RA-102 SECTION

RA-103D, RA-104A, RA-110A SECTION

PRODUCTION CHANGES

Trap Assembly:

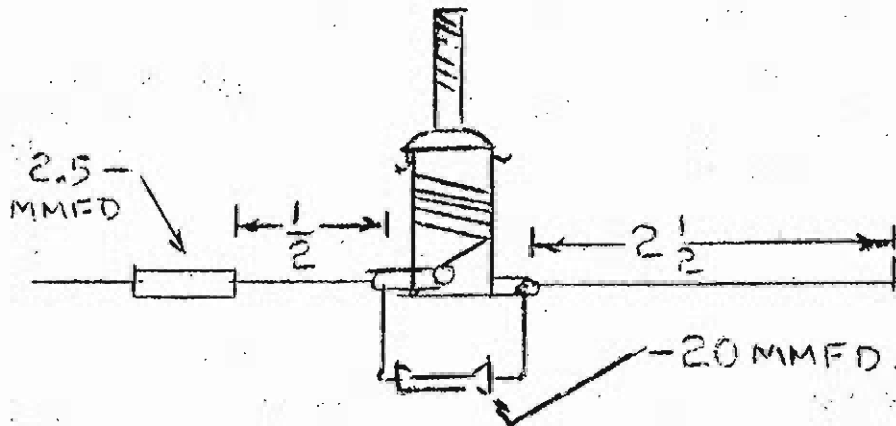
This may be corrected in the field, by the addition of a series-parallel resonant trap in the third video IF amplifier as illustrated in the sketch below:

The parts required are one 2.5 uuf, part #03014570, one 20 uuf, part #03013800 and one inductor assembly, part #21004491. Connect the 2.5 uuf capacitor to the lug to which the end of the winding closest the lug is soldered, leaving $\frac{1}{2}$ " of wire between the body of the capacitor and the lug.

Connect a $2\frac{1}{2}$ " length of #18 bare-tinned copper wire to the other lug of the inductor. Connect the 20 uuf capacitor across both of the lugs of the inductor.

Installation:

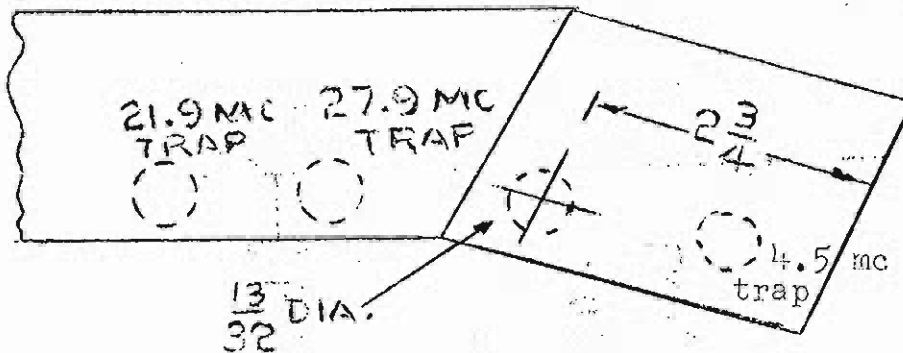
A $\frac{13}{32}$ diameter hole should be carefully punched (using a Parker-Kalon Metal Punch XX) in the video IF amplifier shield plate as shown in the sketch below:

Insert the trap assembly in the hole so that the lugs are parallel to the main chassis, and with the bare wire closest to the main chassis. Solder the bare-tinned wire to pin 3 of the video amplifier (V205). Solder the free end of the 2.5 uuf capacitor to the junction of L212, C288, R218, and Pin 2 of V204-A.

Figure 1

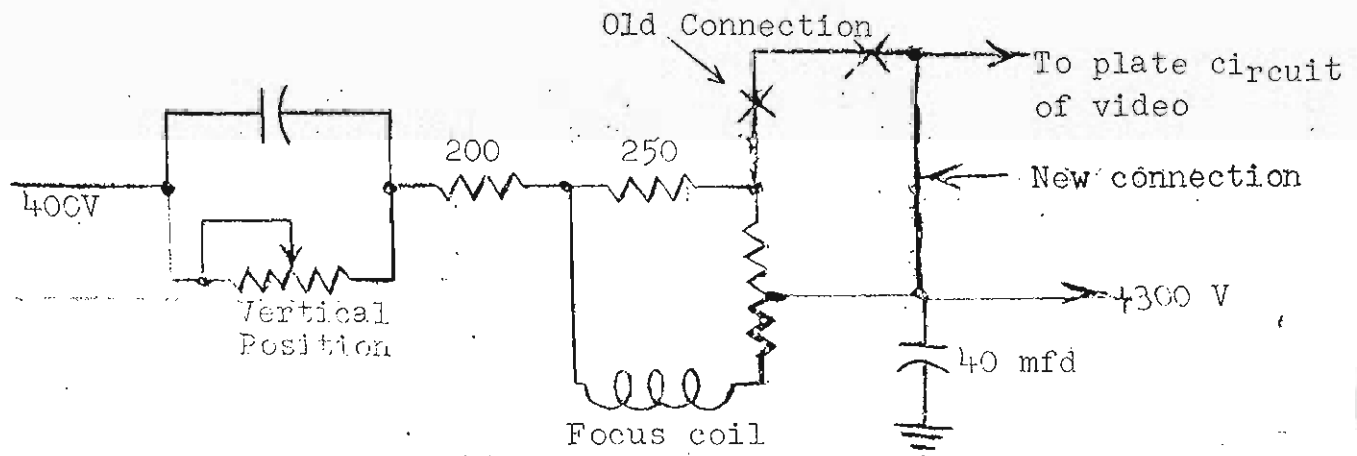
1. In the early models, the plate circuit of V205, the video amplifier, was connected to the junction of R286B and the focus control. With this wiring arrangement, the only time the B+ line going to the video amplifier was completely by-passed by C264B, was when the focus control was at its extreme clockwise position.

In order that this line be adequately by-passed at all times, the B+ line to the video amplifier is now connected to the arm of the focus control. This change is shown in Fig. 1.

This change reduces the B+ voltage of the video amplifier about 25 to 30 volts but does not noticeably affect the operation of this stage.

Figure 2

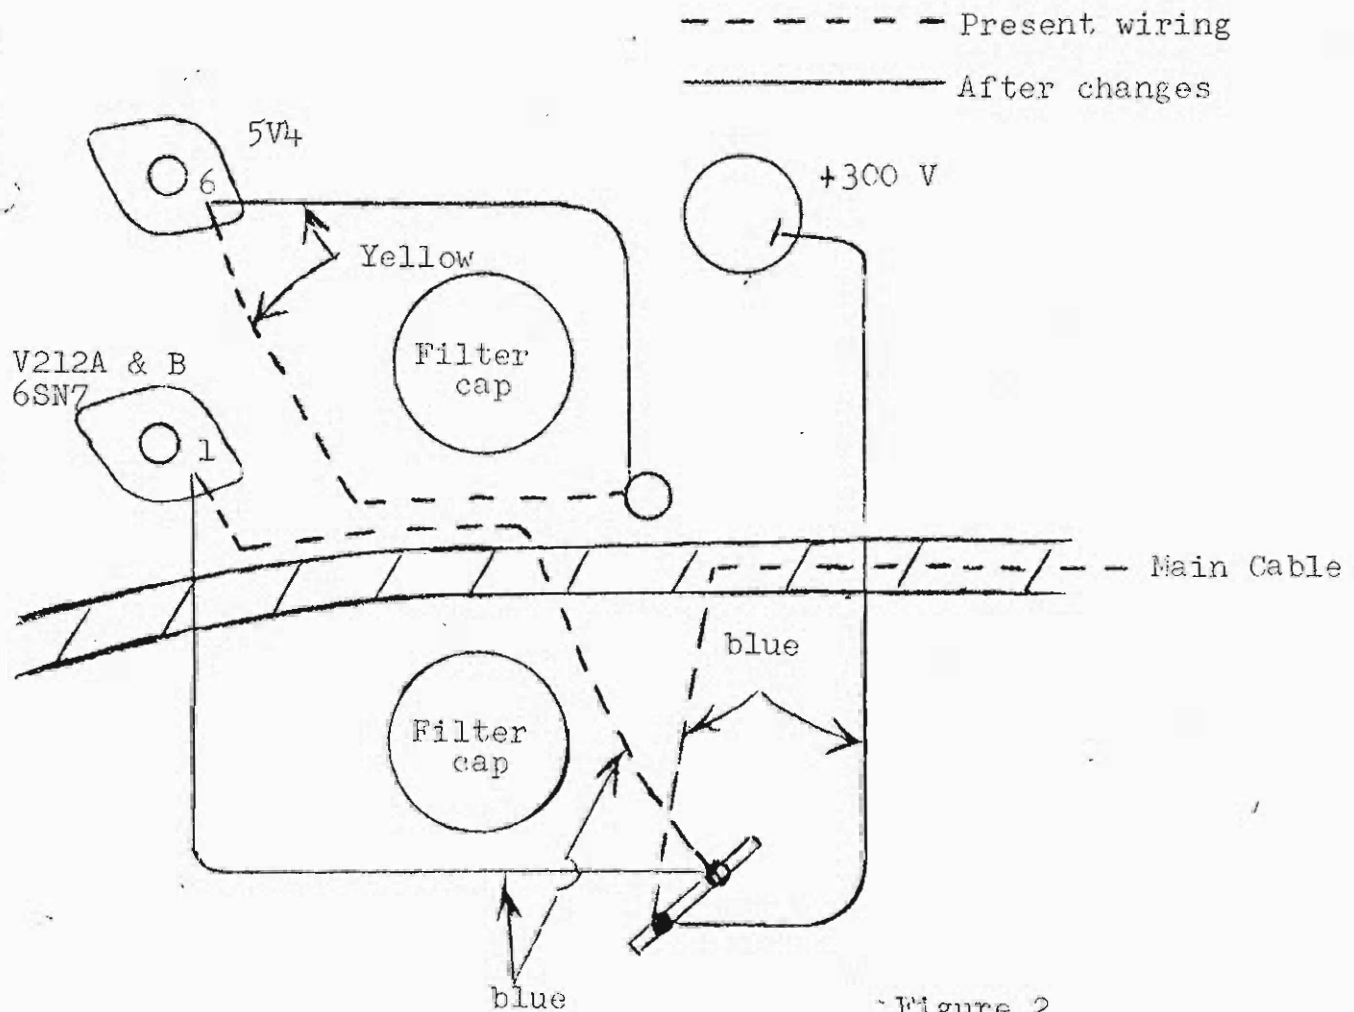
2. In addition to the above wiring change, it was necessary to redress certain leads to eliminate pick up in the sync circuits. The proper lead dress is described in items (a) and (b) below and illustrated in Fig. 2.

(a) The lead from the coupling capacitor (C306) to the grid of the sync clipper (V212A) should not be run under the main cable between the two large filter capacitors. Rather it should go straight from the terminal board toward the rear of the chassis, and then after a 90° turn it goes to the grid of V212A so that it passes under the main cable at right angles.

(b) The lead from the high side of the yoke now goes to pin 6 of the 5V4 by running parallel with the main cable through the space between the two large filter capacitors and then to the 5V4. This lead (colored yellow) should go toward the linearity coil after emerging from the grommet and then after a 90° turn to pin 6 of the 5V4.

Figure 2

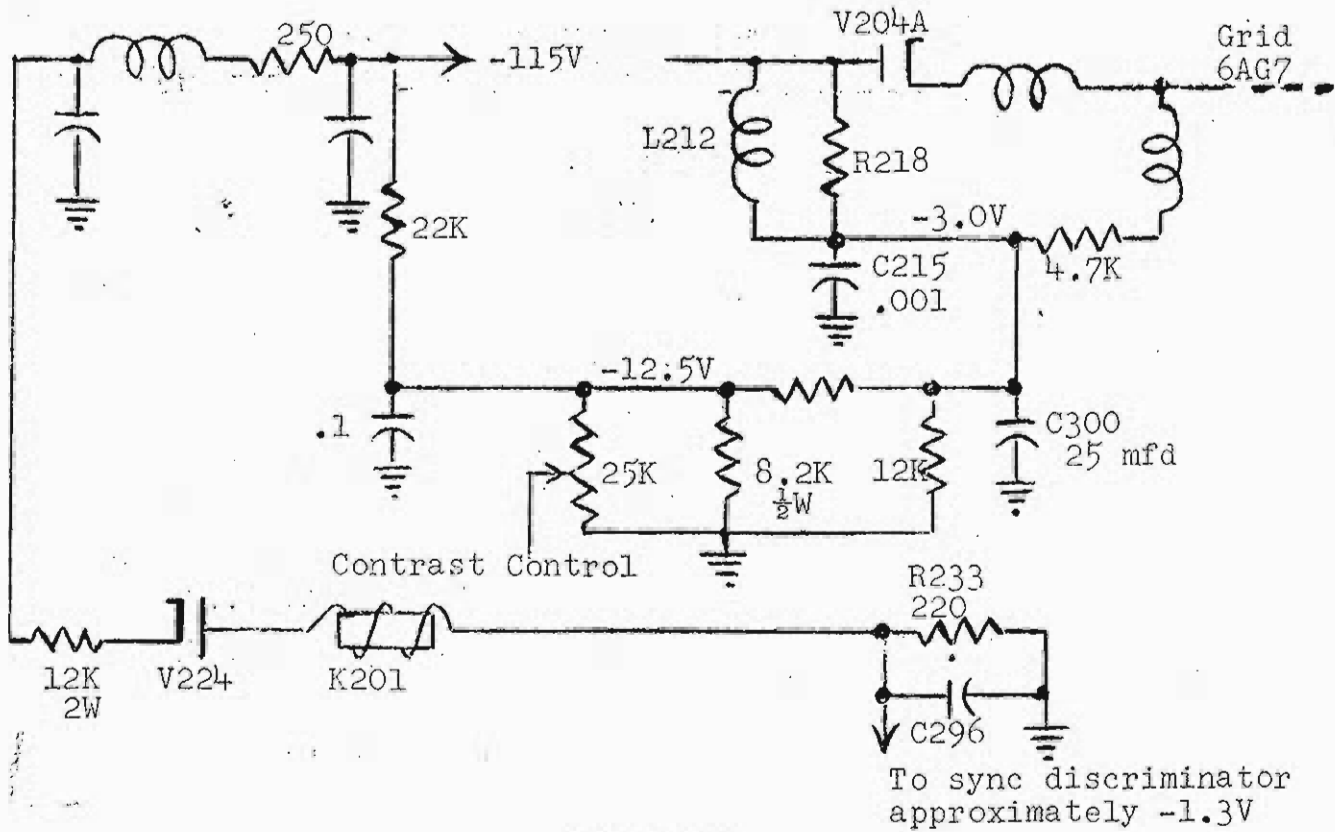
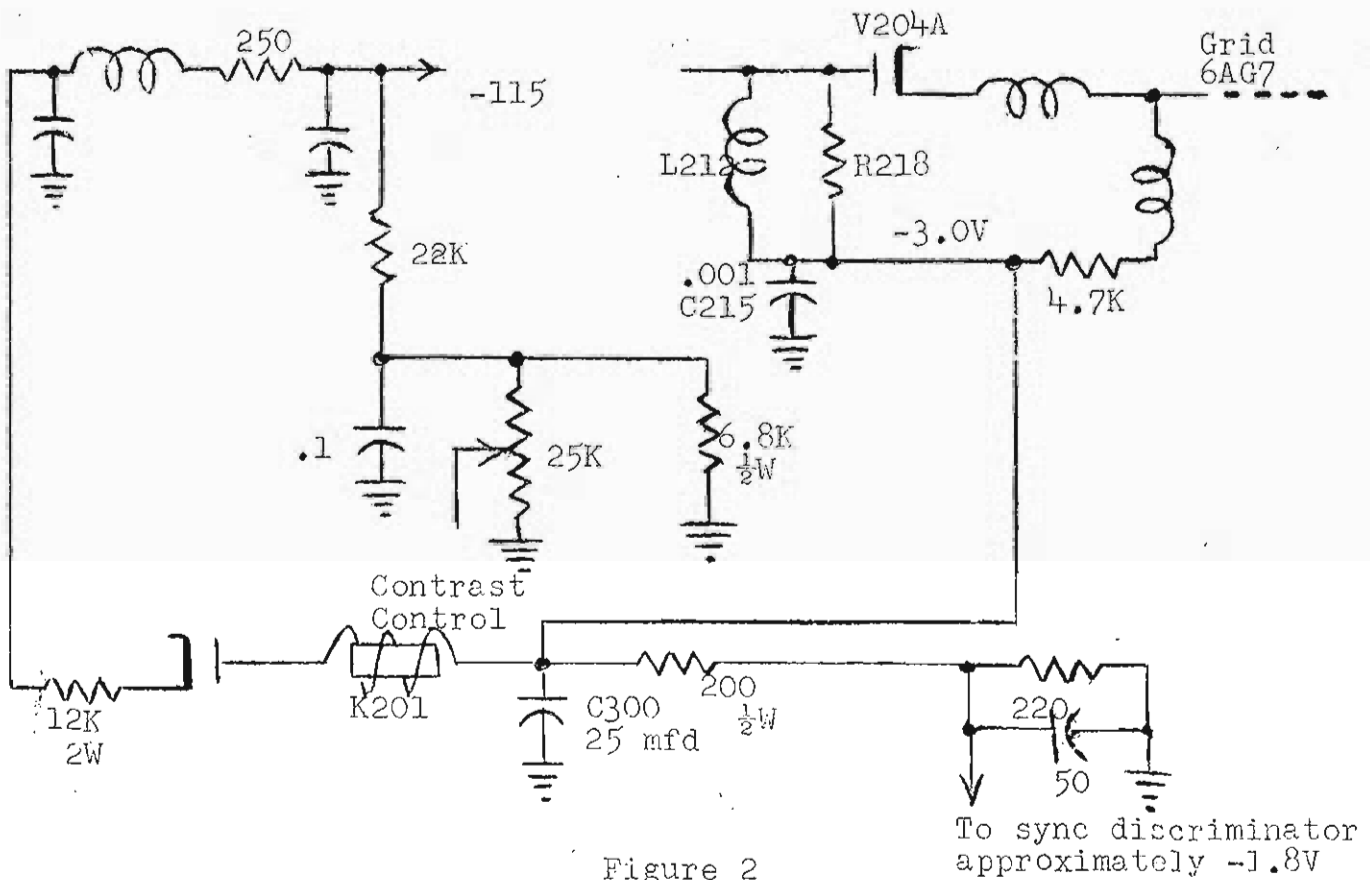
2. Change the bias circuit of the video amplifier V205, from that shown in Fig. 1 to the circuit shown in Fig. 2. In the existing circuit, the bias voltage for the mixer and the video amplifier are taken from the same point. The new bias circuit applies bias to the video amplifier from a different point. The only changes involved follow:

- a. Insert a 200 ohm $\frac{1}{2}$ watt resistor between the relay coil and the junction of R233 and C296.
- b. Remove the connection between C300 and the junction of R337 and R336. Leave C300 connected to the junction of R219, C215, R218 and L212.
- c. Connect the junction of the relay coil and the added 200 ohm resistor to the video amplifier grid circuit at C300.
- d. Remove R216 (8.2K), R336 (27K), and R337 (12K.) Add a 6.8K $\frac{1}{2}$ watt resistor as shown in Fig. 3.

Figure 3
Location of Trap.

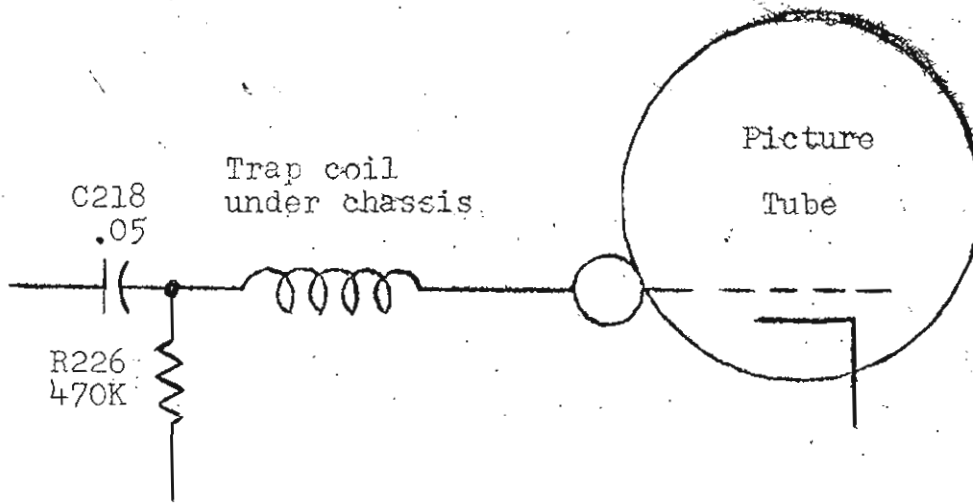
3. Insert a resonant trap coil in series with the CRT grid lead as shown in Figure 3.

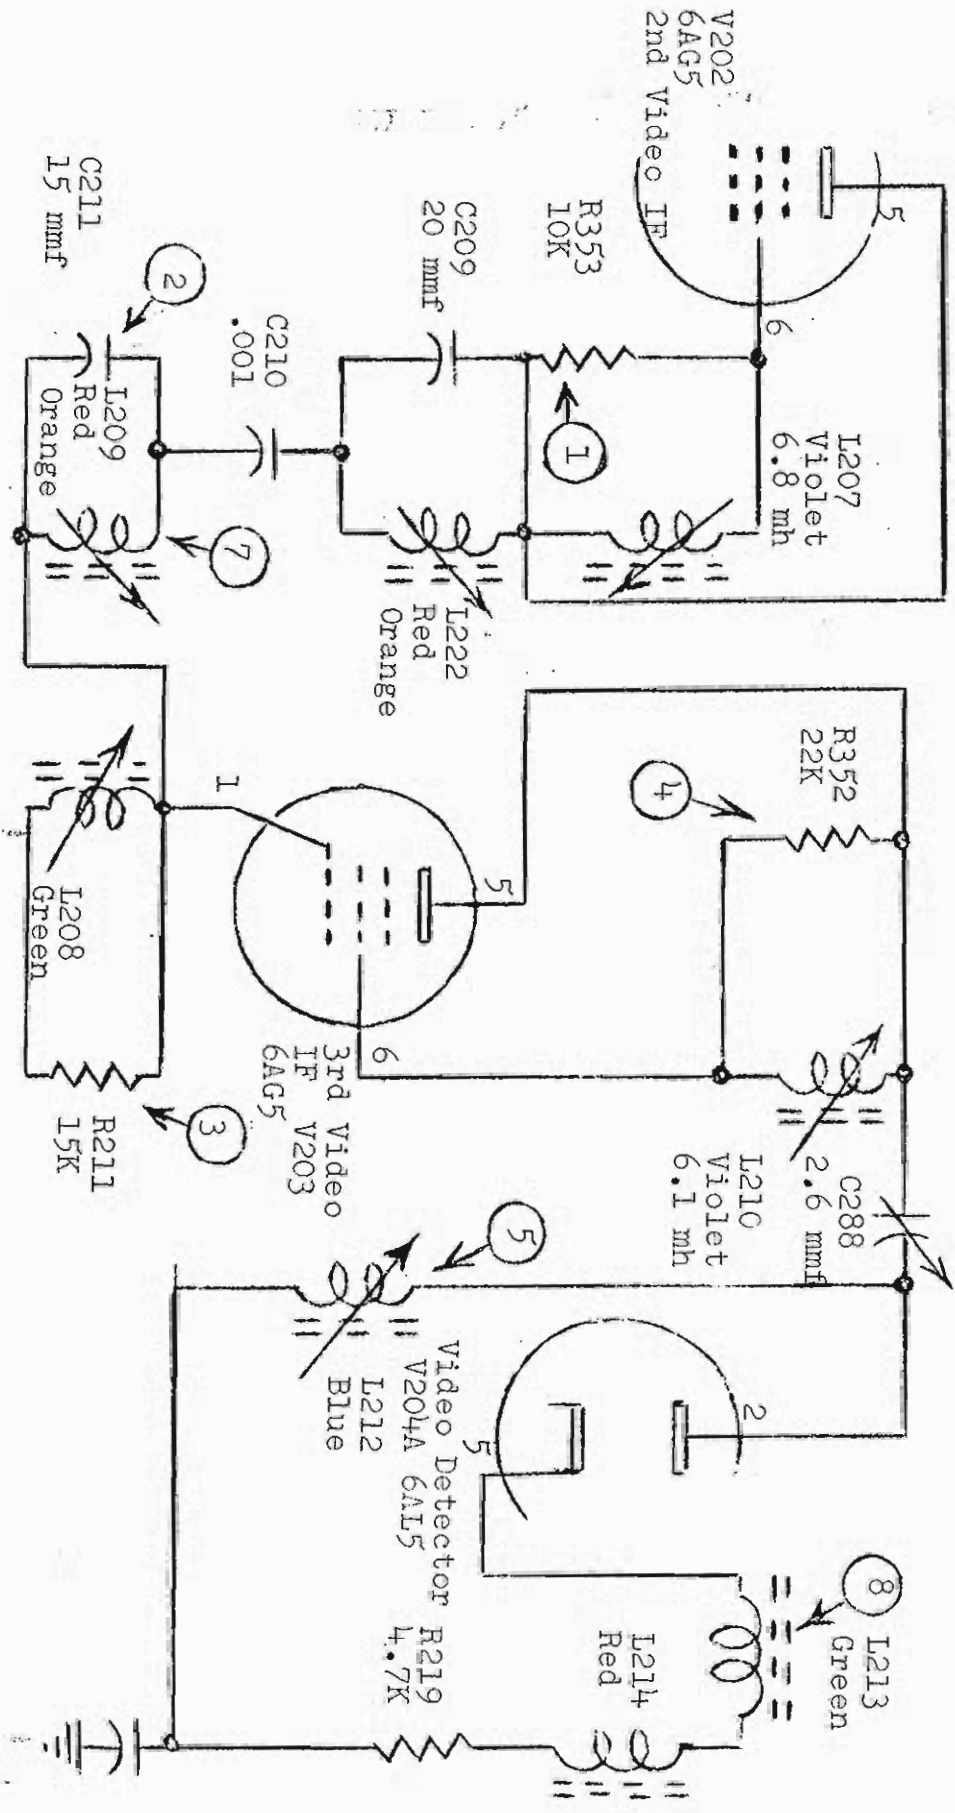
To eliminate this problem, several changes are to be made in the video IF strip and one change in the video amplifier. See Figure 1 for a simplified schematic. Those items affected are indicated by an encircled numeral. The numeral refers to the step to be made in the following procedure.

1. Add a 10K $\frac{1}{2}$ watt 5% resistor across L207. Identify it as R353.
2. Change C211 (connected across L209) from 10 mmf 500V to 15 mmf 500V
3. Change R211 from 3.9K $\frac{1}{2}$ watt to 15K $\frac{1}{2}$ watt.

4. Add a 22K $\frac{1}{2}$ watt 5% resistor across L210. Identify it as R352.
5. Remove R218, the 18K $\frac{1}{2}$ watt resistor connected across L212 in the video detector input circuit. (In earlier sets R218 was 39K and in some of the later sets there are two 39K resistors connected in parallel. See change #7 on page 12a of this section).

6. Add a 22K $\frac{1}{2}$ watt 10% resistor across C217 and L216. (This is the 4.5 mc trap). Identify it as R351. (not shown in Fig.1)
7. Change L209 (color code red white) part number 21004801 to part number 21004802 (color code red orange).

8. Change L213 (color code yellow) part number 21004467 to (color code green) part number 21004464.

Refer to Fig. 2A showing the old or unmodified circuit and Fig. 2B showing the new or modified circuit when making the following changes:

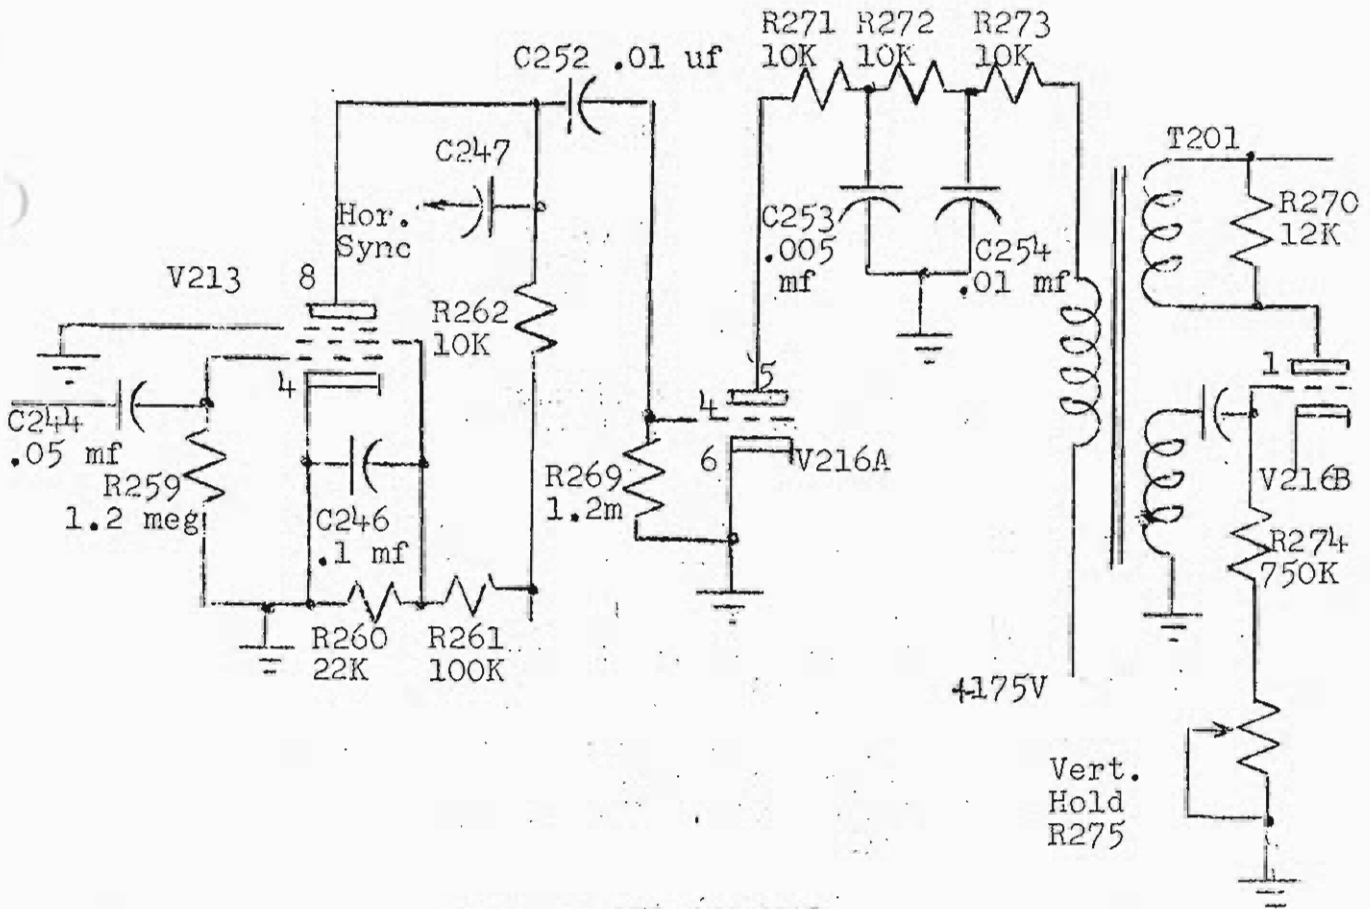
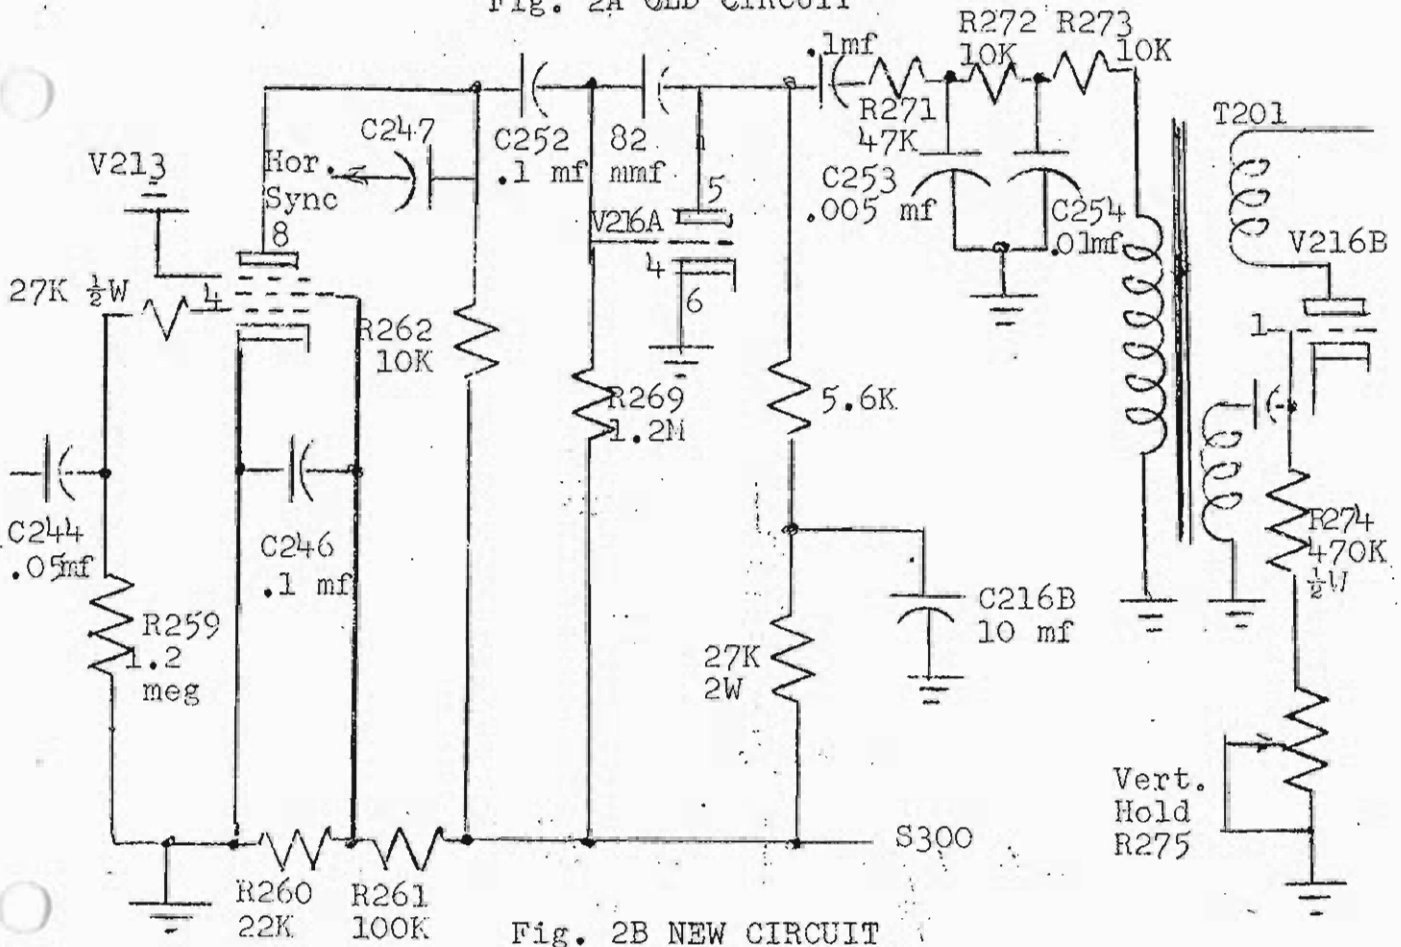
10. Add a 27K $\frac{1}{2}$ watt resistor between the junction of C244 and R259 and pin #4 of V213.
11. Remove capacitor C252 (between pin #8 V213 and pin #4 V216A) and replace with 0.1 mf capacitor.

12. Disconnect the ground side of R269 (grid circuit of V216A). This will be connected in step #17.
13. Connect an 82 mmf capacitor between pins #4 and #5 of V216A.

14. Disconnect R271 (10K) from pin #5 of V216A. (This resistor will be replaced in step #18).
15. Connect a 5.6K $\frac{1}{2}$ watt resistor to pin #5 V216A.

16. Connect the other end of the 5.6K resistor just added to a 27K 2 watt resistor. Run a lead from the junction of these two resistors to C216B.
17. The other end of the 27K 2 watt resistor is to be connected to the junction of R262 and R261 and to the low side of R269 the 1.2M resistor in the grid circuit of V216A.

18. Replace R271 with a 47K $\frac{1}{2}$ watt resistor.
19. Connect a .1 mfd capacitor between pin #5 of V216A and the 47K just added.
20. Disconnect the blue lead of the primary of T201 from the +175 volt line and run directly to ground.

21. Remove R270 (the 12K resistor connected across the Brown Black winding of T201)
22. Remove R274, the 750K resistor located between pin #1 of V216B and the vertical hold control and replace with a 470K $\frac{1}{2}$ watt resistor.
